SERVICE BULLETIN

Service Bulletin #: SB04

Title: Ammeter Display Removal.

Figure 1: MFD with Compact Flash Cover Removed

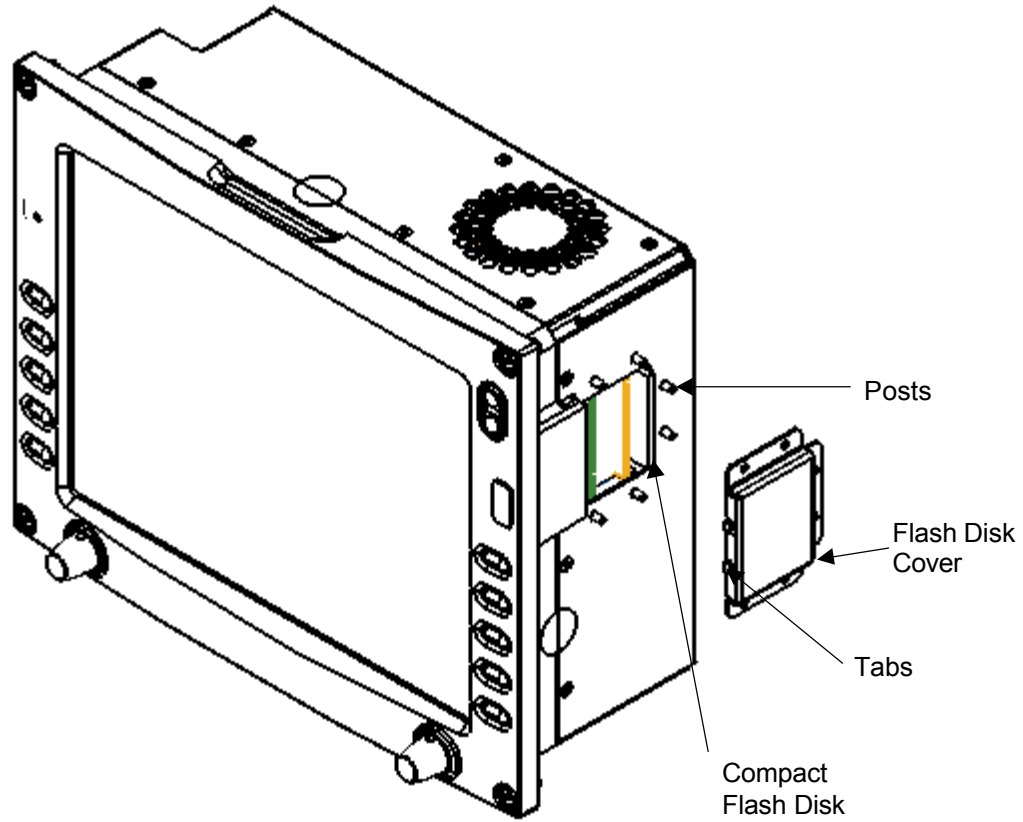
This procedure should be performed on the bench. Ensure NO power is applied to the unit. Refer to Figure 1.

1. Remove the Flash cover by unscrewing the 6 nuts and lifting the cover off the posts.
2. Remove the compact flash (See Effectivity/Compatibility) by pulling it from the connector and sliding it out (as shown in Figure 1).
3. Record

1. Orient the compact flash by locating the red arrow. This indicates which edge of the device slides in first. The compact flash is keyed, so it will only slide in one way. Look for two small indentations on opposite edges of the device. They should be on the side of the compact flash that faces the front of the unit.
2. Slide the 530-00117-000 Rev 01 compact flash into the slot.
3. Ensure the compact flash is fully seated.
4. Replace the compact flash cover.
5. Secure cover with the nuts.
